# Tees CCPP Project

## The Tees Combined Cycle Power Plant Project

### Land at the Wilton International Site, Teesside

### Implications of Requested Change on the EIA

Viewpoint 1  
View from Lazenby Allotments

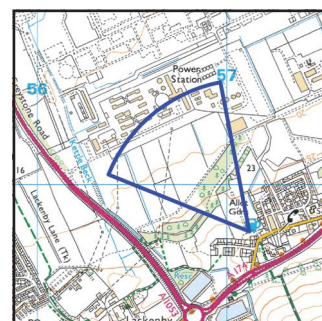
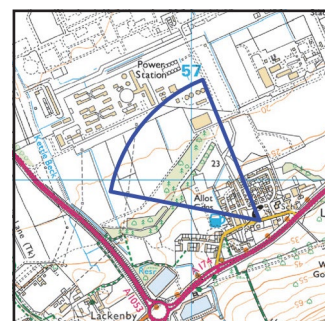
| Viewpoint                   | Sensitivity | Construction Phase Effects   | Magnitude of Change | Significance of Effect | Operational Phase Effects   | Magnitude of Change   | Significance of Effect |
|-----------------------------|-------------|--|---------------------|------------------------|---|---|------------------------|
| VP1- view from allotments   | Medium H/R  | Scrub vegetation and trees to the south and southeast of Project site will restrict views towards lower construction activities. Taller construction equipment such as cranes will, however, be visible. Considering the temporary nature of the construction activities and the visual dominance of existing infrastructural elements, the magnitude of change is considered to be small. | Small               | <i>Not Significant</i> | Scrub vegetation and trees to the south of site will restrict views towards lower Project components. The main bulk of taller components like the heat recovery steam generator and turbine hall will be barely visible through the vegetation. The stacks and the upper portions of the HRSG buildings and a small part of one gas turbine buildings (albeit against the backdrop of the larger HRSG buildings) will be visible above the trees and hedgerows. | The stacks' and the upper portions of the HRSG buildings will be visible and will be seen alongside the Ensus plant and other stacks and electricity Pylons. The magnitude of change is therefore considered to be <i>Small</i> . | <i>Minor</i>           |
|                             |             | At night construction lighting will be barely perceptible in the background of the view. Existing operational and security lighting around Ensus Plant as well as lights along A1053 will be dominant. Therefore, the magnitude of change is considered to be negligible.  | Negligible          | <i>Not Significant</i> | At night, operational and security lighting associated with the Project will be perceptible in the background of the view especially at higher levels and on stacks. This will be seen alongside existing lighting around Ensus Plant, the magnitude of change is considered to be small.   | <i>Small</i>  | <i>Minor</i>           |

Updated Wireline with outline of hidden plant in red - after requested change

Viewpoint 4  
View from Lazenby High Street

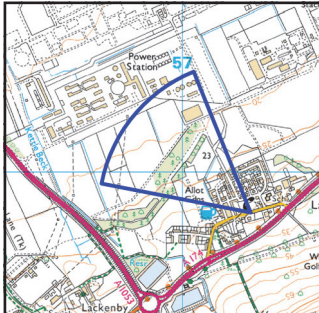
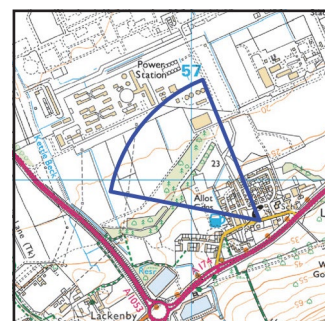
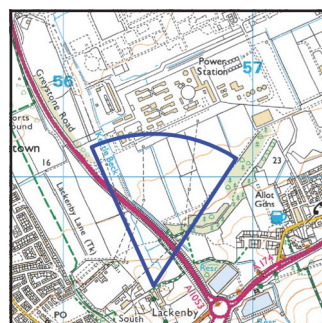
| Viewpoint                                   | Sensitivity  | Construction Phase Effects   | Magnitude of Change     | Significance of Effect                               | Operational Phase Effects  | Magnitude of Change   | Significance of Effect  |
|---|--------------|--|-------------------------|--|--|---|---|
| VP4- view from High Street , Lazenby        | High H, R, T | Views to site are restricted due to intervening residences. Taller construction equipment such as cranes will be barely visible.   | Negligible              | <i>Not Significant</i>                               | Views to site are restricted due to intervening residences. The two stacks and the upper portions of the HRSG buildings are the only visible components of the Project and will be seen alongside other taller components within the industrial area.  | Magnitude of change is considered to be <i>Small</i> .                                      | <i>Minor to Moderate</i> . Given the fact that there are other tall industrial components in the skyline, like the Ensus plant and pylons, the range of effect is more towards <i>Minor</i> . |

Updated Photomontage - after requested change

Structure dimensions  
 Turbine building: 55m x 80m x 32m high  
 HRSG building (including vents): 35m x 55m x 45m high  
 Stack: 75m high

Viewpoint 5  
View from Rosedene Cattery

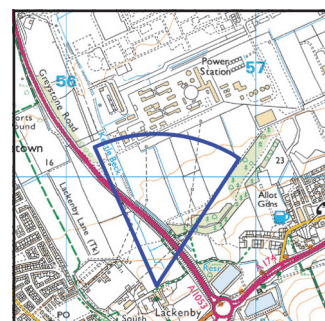
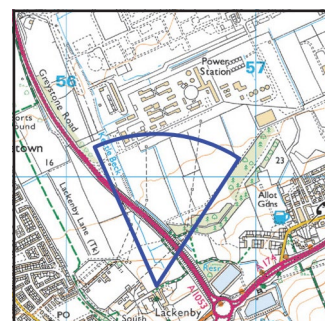
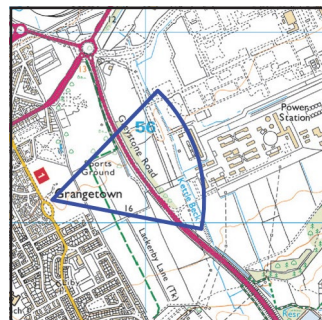
| Viewpoint                                       | Sensitivity    | Construction Phase Effects  | Magnitude of Change | Significance of Effect | Operational Phase Effects  | Magnitude of Change  | Significance of Effect |
|---|----------------|---|---------------------|------------------------|--|--|------------------------|
| VP5-view from Rosedene Cattery                  | Medium H       | Effects very similar to VP1.  | Small               | <i>Not Significant</i> | Scrub vegetation and trees to the south of site will restrict views towards lower Project components. As well as the stacks, upper parts of the taller components (the heat recovery steam generator and gas turbine hall) will be visible alongside the Ensus Plant, electricity pylons, A1053 and industrial area in the backdrop. | Magnitude of change is considered to be Small considering the large electric substation in the foreground and industrial area in the background. | <i>Minor</i>           |
|   |                | Impacts due to lighting are similar to VP1  | Negligible          | <i>Not Significant</i> | Impacts due to lighting are similar to VP1   | <i>Small</i>   | <i>Minor</i>           |

Updated Wireline - after requested change

Structure dimensions  
 Turbine building: 55m x 80m x 32m high  
 HRSG building (including vents): 35m x 55m x 45m high  
 Stack: 75m high

Viewpoint 6  
View from Birchington Avenue

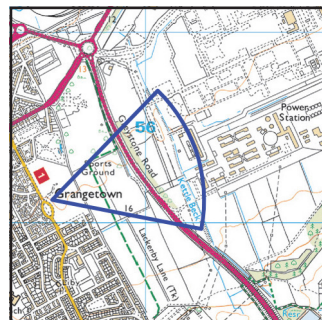
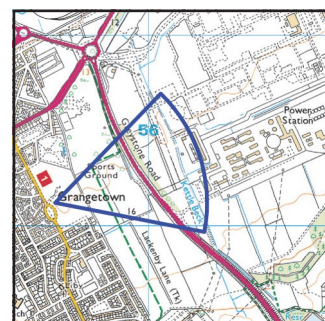
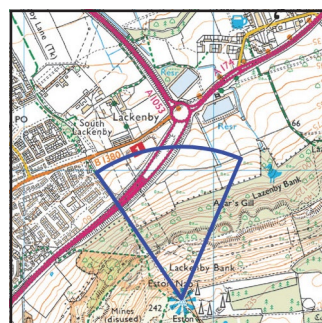
| Viewpoint                                       | Sensitivity    | Construction Phase Effects  | Magnitude of Change | Significance of Effect | Operational Phase Effects  | Magnitude of Change  | Significance of Effect |
|---|----------------|---|---------------------|------------------------|--|--|------------------------|
| VP6- view from Birchington Avenue               | Medium H, R, T | Views to the site are restricted due to intervening vegetation in the green infrastructure corridor. Taller construction equipment such as cranes will be barely visible. | Negligible          | <i>Not Significant</i> | Intervening vegetation in the green infrastructure corridor will restrict views of the Project. The only visible elements of the Project will be of the two stacks seen alongside the stack of Ensus plant, together with the upper portions of the HRSG buildings.  | Magnitude of change is considered to be <i>Small</i> .   | <i>Minor</i>           |
|   |                | Impacts due to lighting are similar to VP1  | Negligible          | <i>Not Significant</i> | Impacts due to lighting are similar to VP1.  | <i>Small</i>   | <i>Minor</i>           |

Updated Wireline with outline of hidden plant in red - after requested change

Structure dimensions  
 Turbine building: 55m x 80m x 32m high  
 HRSG building (including vents): 35m x 55m x 45m high  
 Stack: 75m high

Viewpoint 10  
View from Eston Nab

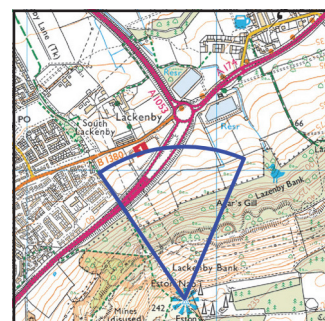
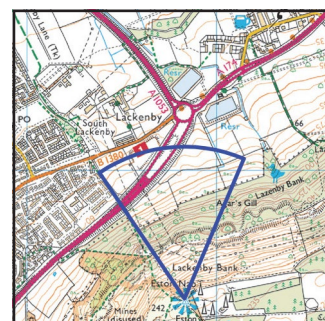
| Viewpoint                      | Sensitivity | Construction Phase Effects  | Magnitude of Change | Significance of Effect | Operational Phase Effects  | Magnitude of Change                                     | Significance of Effect |
|--------------------------------|-------------|---|---------------------|------------------------|--|---|------------------------|
| VP10- View from Eston Nab(SAM) | Medium<br>R | Long medium distance views to the site and the Teesside industrial area are available. Construction equipment will be visible although it will be in the backdrop of a very large industrial area.  | Negligible          | <i>Not Significant</i> | The Project will be visible alongside the Ensus Plant and in the backdrop of the Teesside industrial area.   | Magnitude of change is considered to be <i>Small</i> .  | <i>Minor</i>           |

1.23 As can be seen in Table 2.1 earlier in this document, the landscape and visual assessment of the requested change does not alter the magnitude of impact or significance of effects at any viewpoint. This includes for example the viewpoint 10 Eston Nab Scheduled Monument where the requested change will be most visible since the Project will not be screened as in the closer views. However, from this long distance view the Project will be viewed in

Updated Photomontage - after requested change

Structure dimensions  
 Turbine building: 55m x 80m x 32m high  
 HRSG building (including vents): 35m x 55m x 45m high  
 Stack: 75m high
